Re: Marriott Hotel As-built and Drainage Improvements (File No. J-18-D1).

Re: Marriott Hotel As-built and Drainage Improvements
Dated 8/82 (File No. J-18D)

Re: Marriott Hotel site as-built and drainage improvements

Office of the City Engineer
Building Plans
Drainage Review

STATION: 9+05

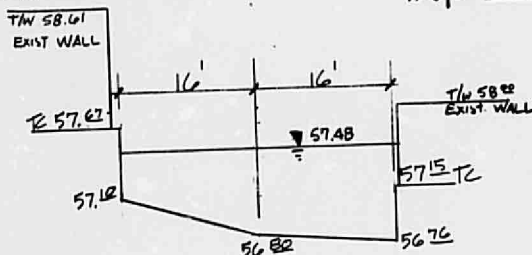
The water at Station 9+05 must turn almost 90°, therefore the water must back up at that point. The energy grade line at Station 9+05 is elev. 58.05, therefore the maximum high water at that point was considered to be 58.00. It can be seen that the existing walls at Station 9+05 will direct most of the flow down the street but there will be some flow through landscaped areas in the area of Station 9+55, and at design flow some plantings may be lost, but the owner is aware of this potential problem and considers it to be a minor problem.

STATION: 9+80

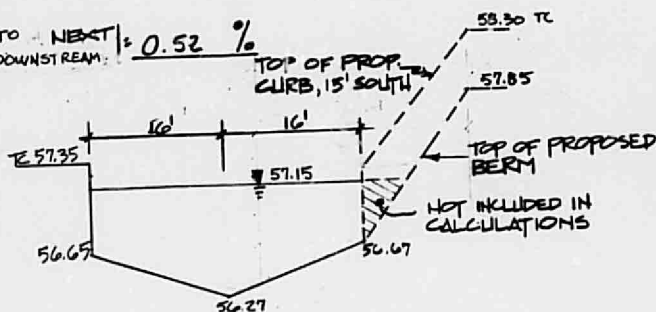
The energy grade line at Station 9+80 is elev. 57.61 and the top of the proposed berm to be elev. 57.85, which should contain the flow even in the event of a hydraulic jump at that point.
